GREAT WOLF LODGE, CHESTERTON, BICESTER

Proposed Non-Material Amendment (S.96a) Application Design Changes

November 2023

This document has been prepared by EPR Architects in support of a Non-Material Amendment (NMA) application associated with proposed changes to application ref 21/04158/F.

Proposed Amended Scheme - Ground Floor

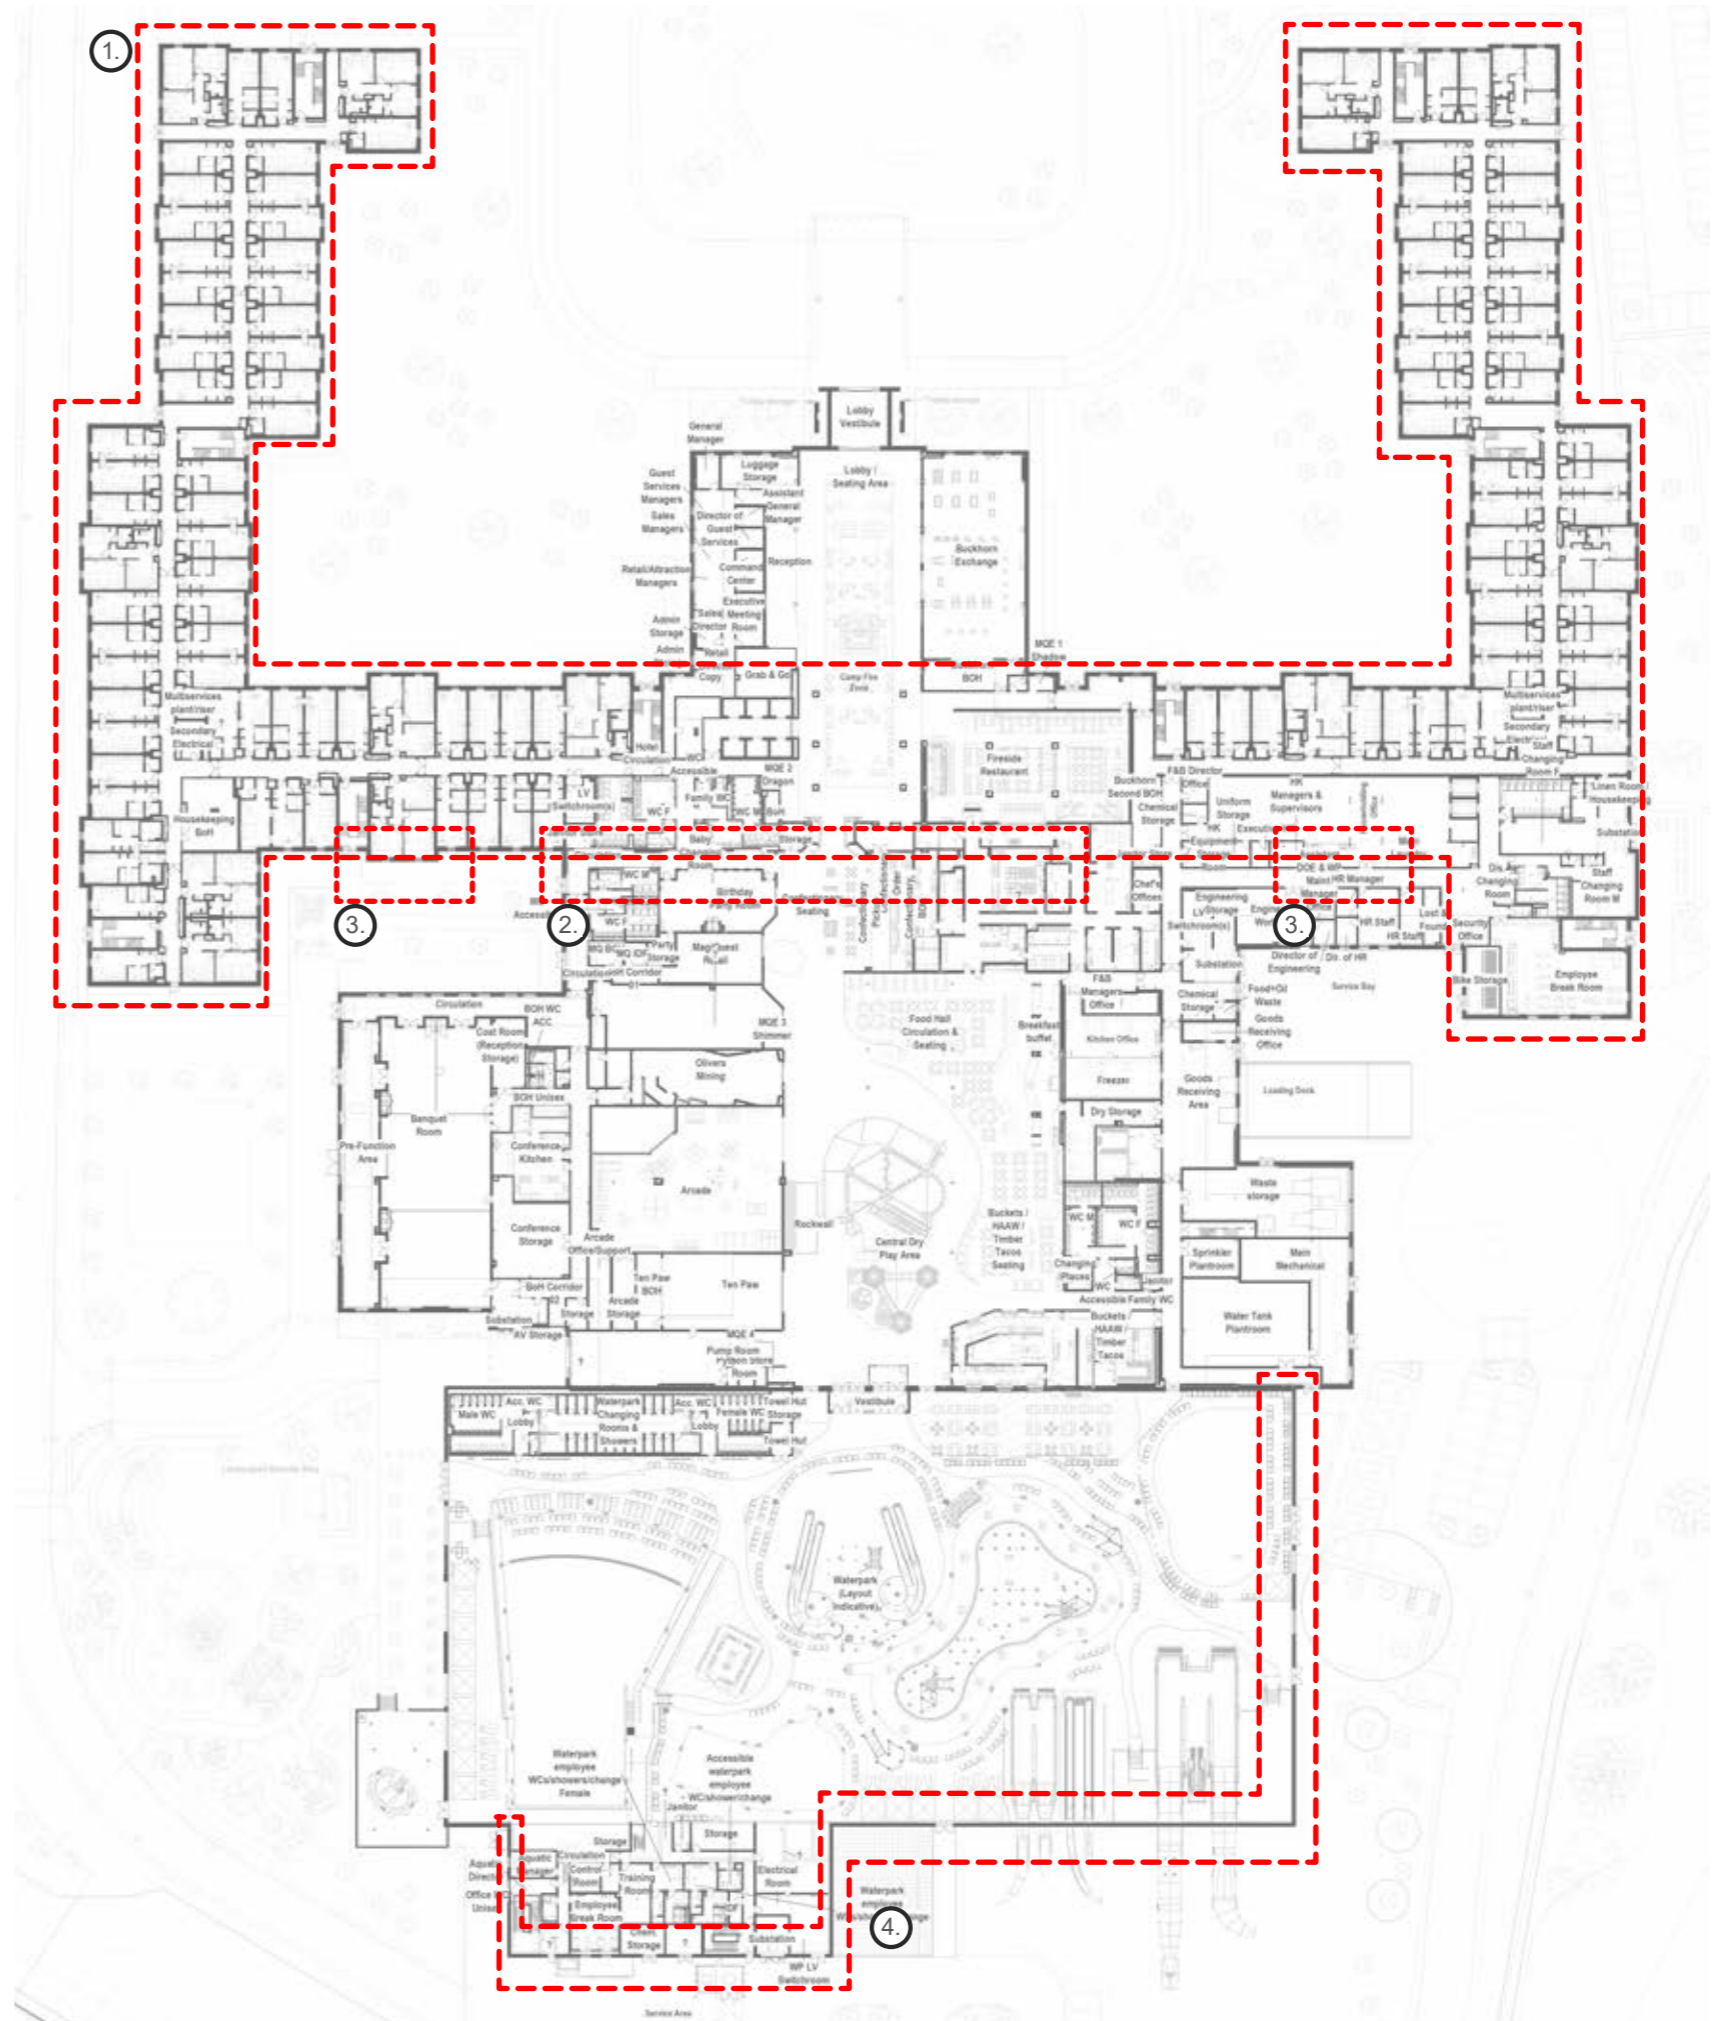
- ① Introduction of Ventilation grilles above all guestroom windows.
- ② Change to part of rear of hotel from stone to render retaining stone surrounds and sills Change of rear of hotel from stone to timber with timber surrounds and metal sills
- ③ Change of rear of hotel from stone to timber with timber surrounds and metal sills
- ④ Reduction of height of brick plinth to back of house areas of waterpark building

Note: Internal layouts shown for information - minor reduction in quantity of risers shown in hotel wings as MEP strategy was developed further

2.2 Scheme Changes Update Proposed Amended Scheme - Roof Plan

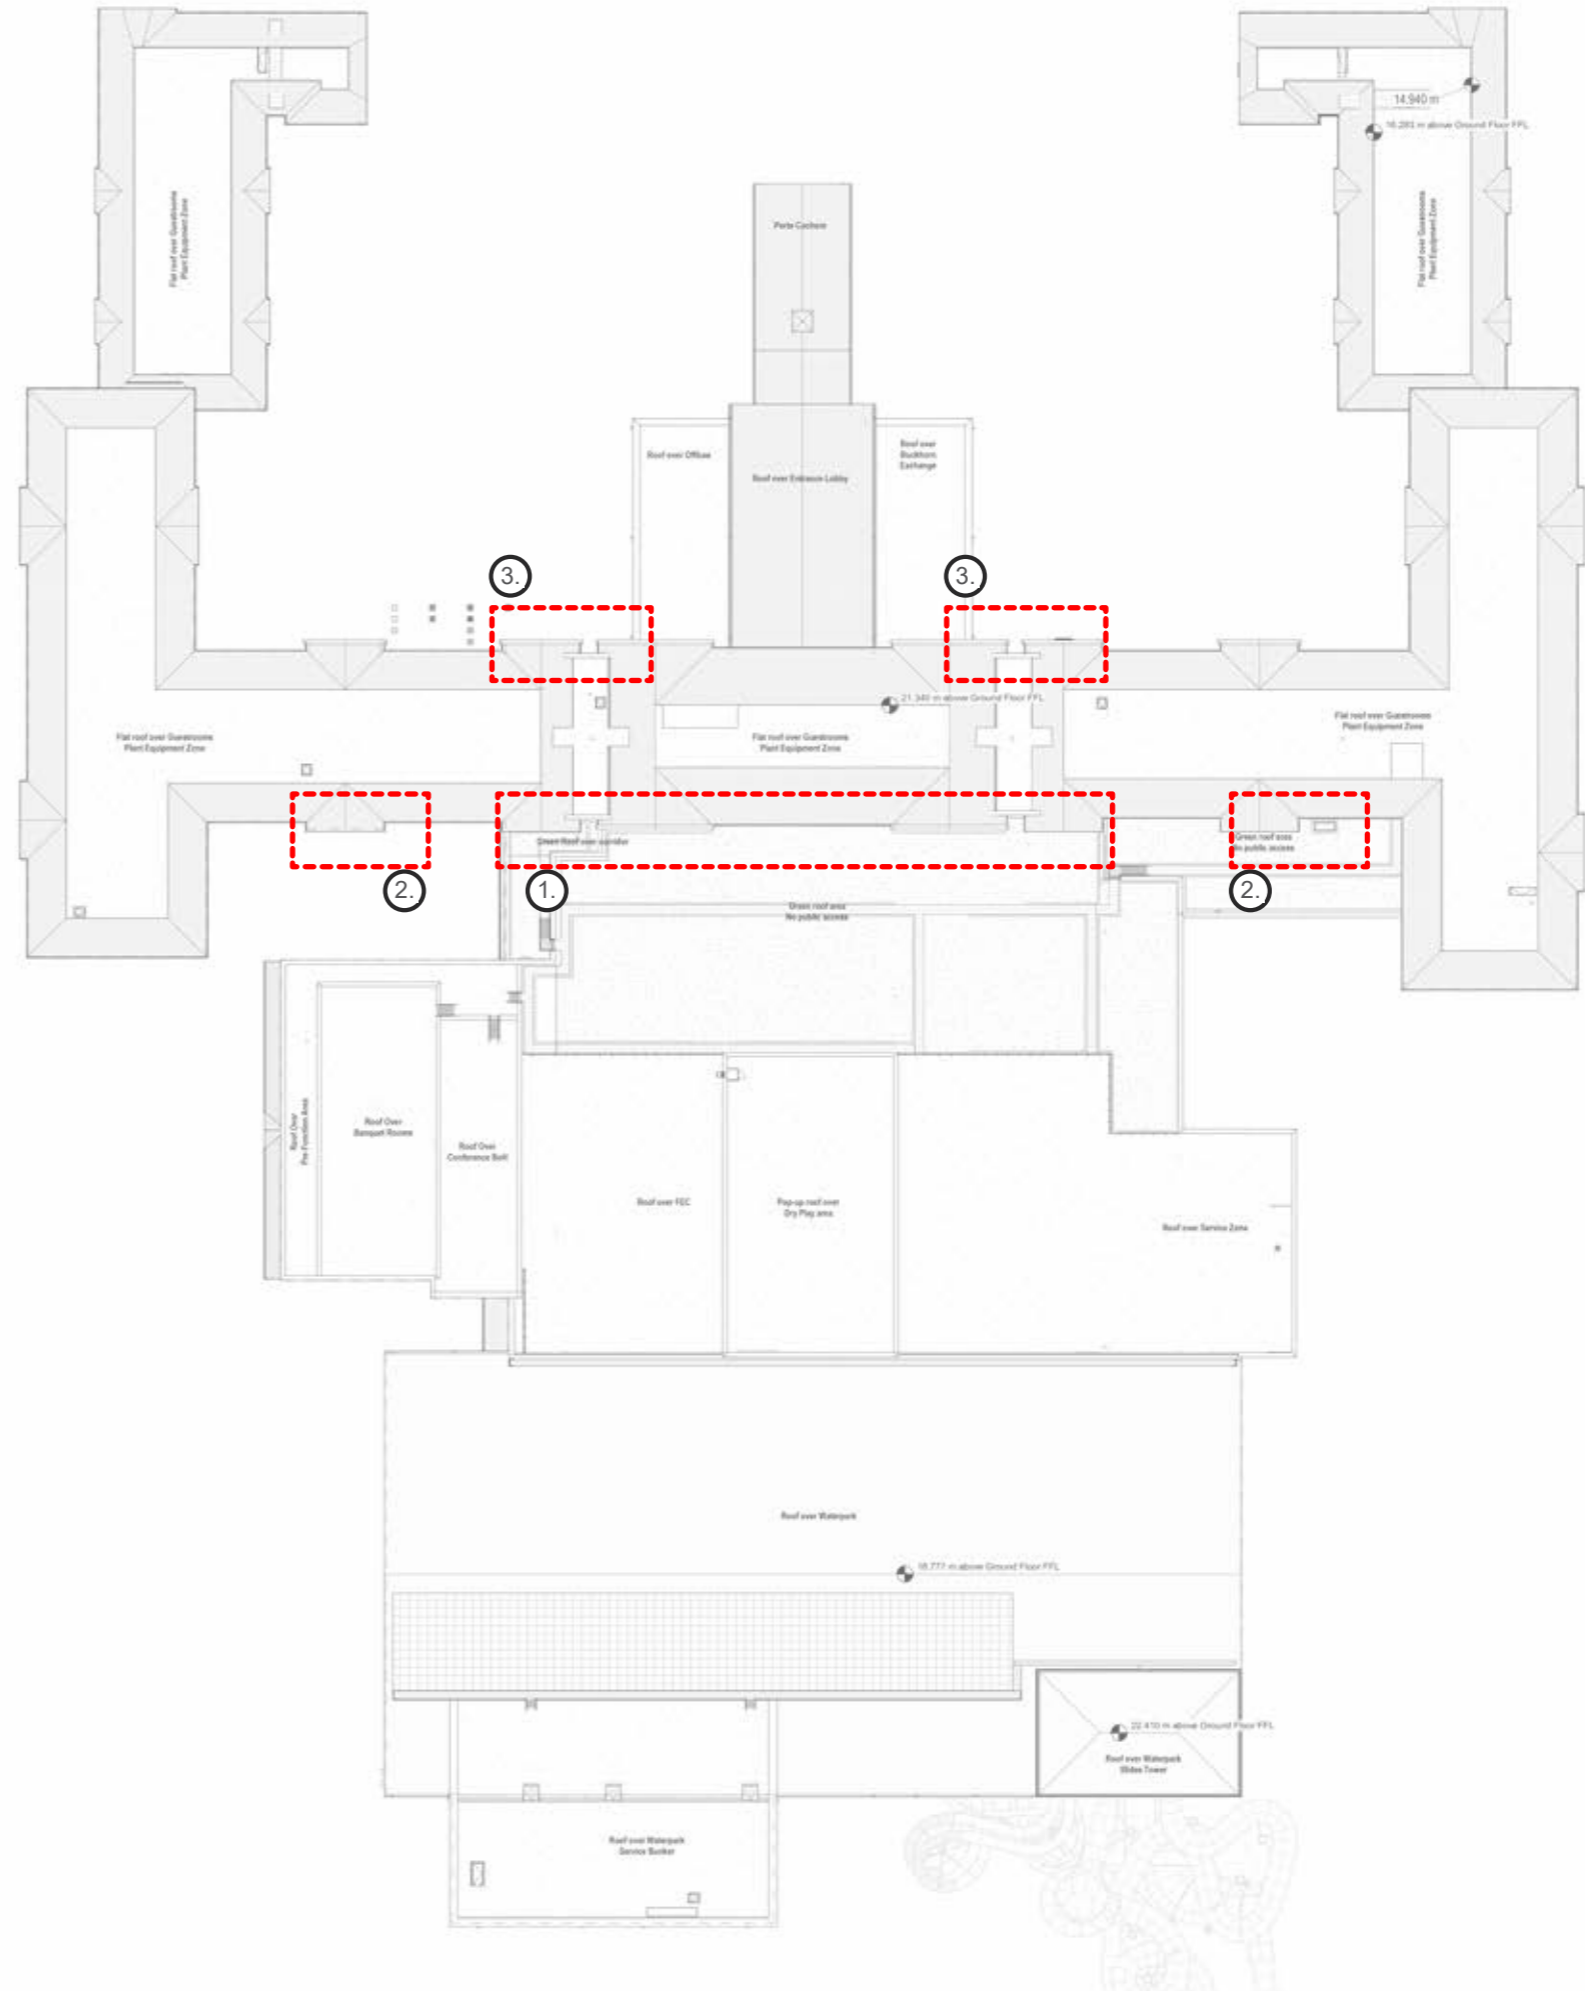
- ① Change to part of rear of hotel from stone to render retaining stone surrounds and sills Change of rear of hotel from stone to timber with timber surrounds and metal sills
- ② Change of rear of hotel from stone to timber with timber surrounds and metal sill
- ③ Reposition slot windows to eaves to raise them slightly.

Proposed Amended Scheme - North-West Elevation

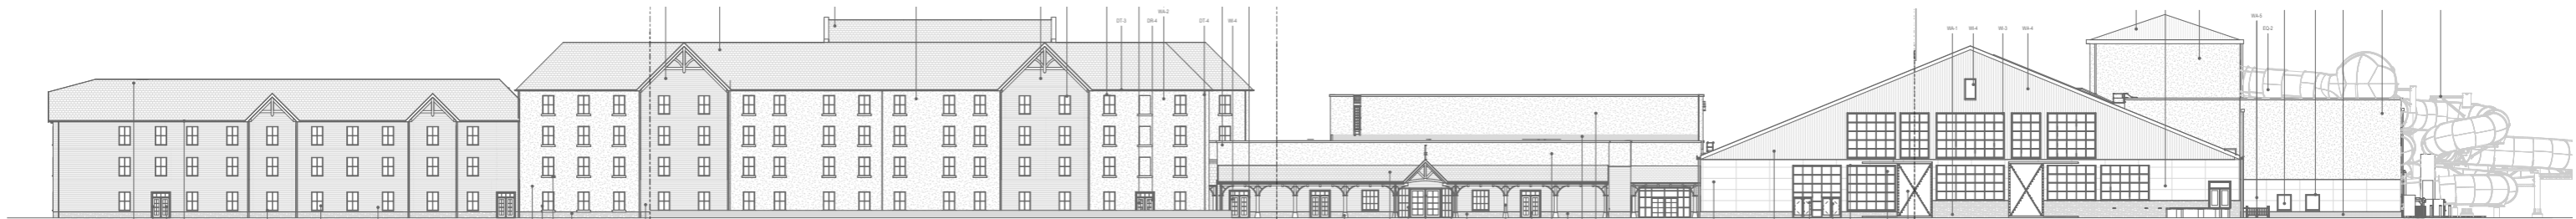
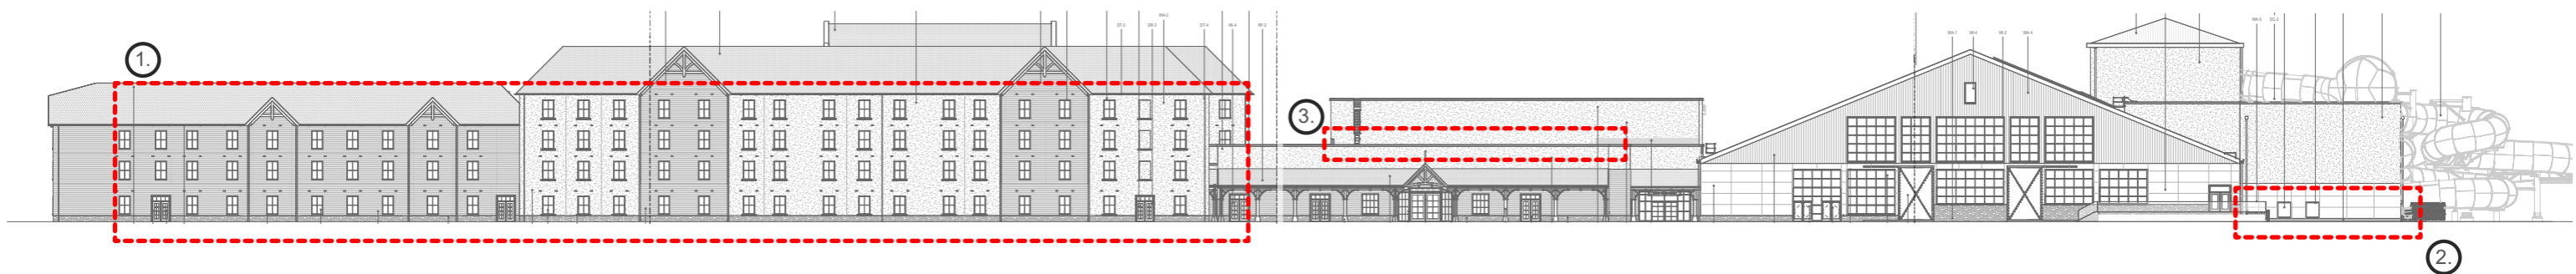
- ① Introduction of ventilation grilles above all guestroom windows
- ② Reduction of brick plinth to back of house areas of waterpark building
- ③ Reduction of plant screening above conference zone

Proposed Amended Scheme - North-West Elevation

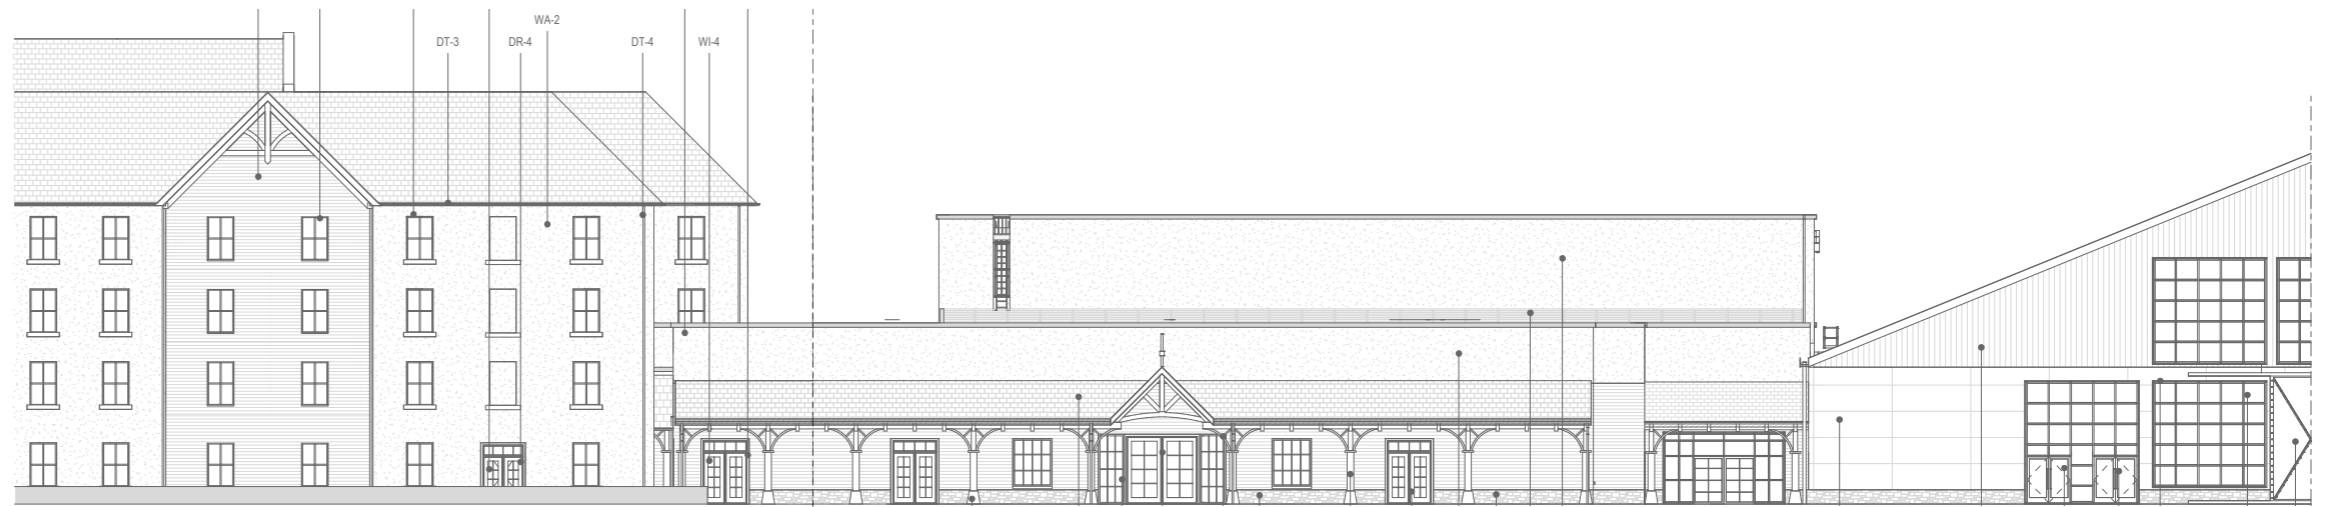
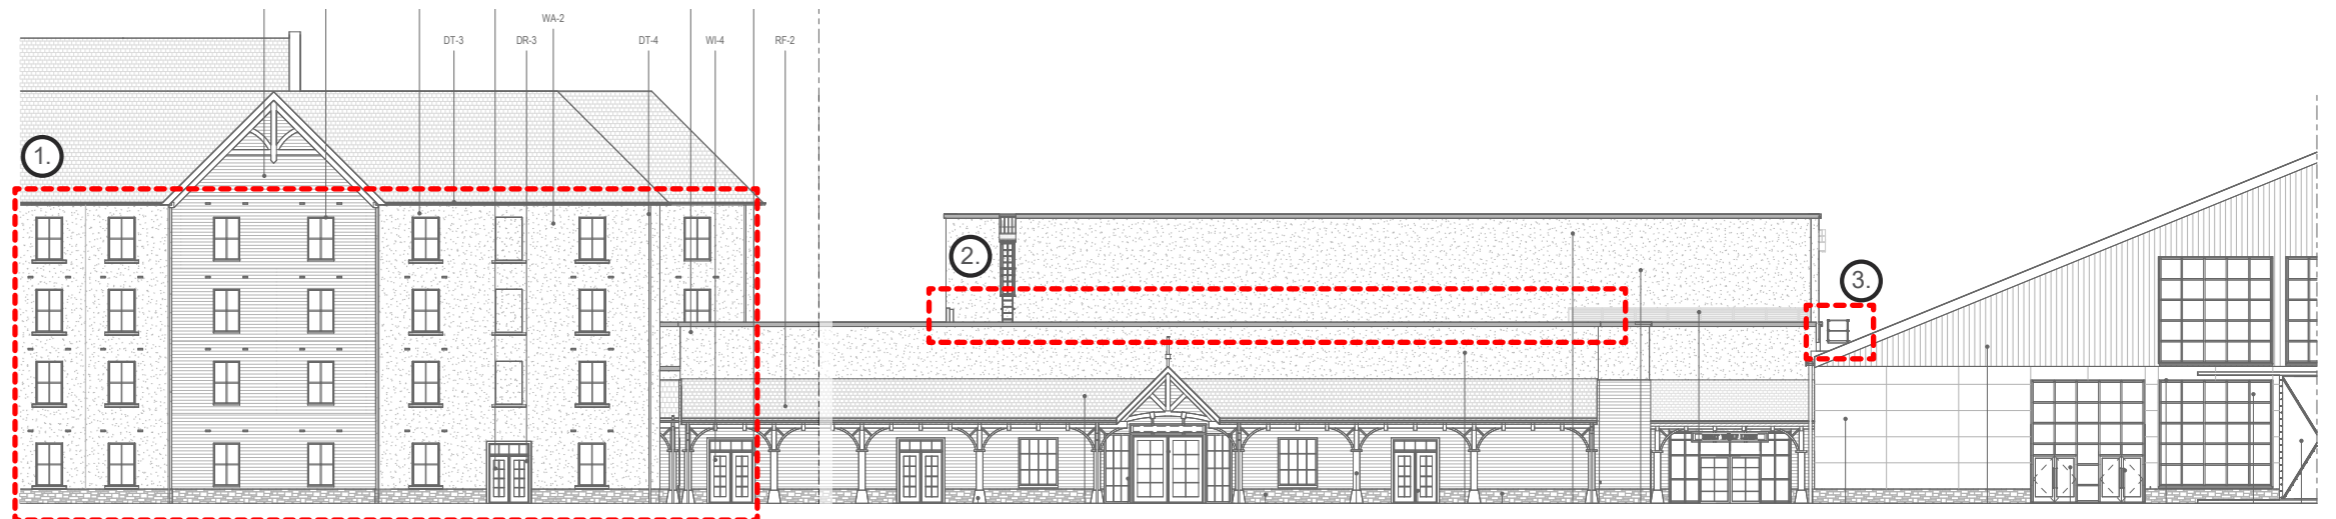
- ① Introduction of ventilation grilles above all guestroom windows
- ② Reduction of extent of plant screening above conference zone where plant is no longer present.
- ③ 250mm width increase of roof access platform for safer access.
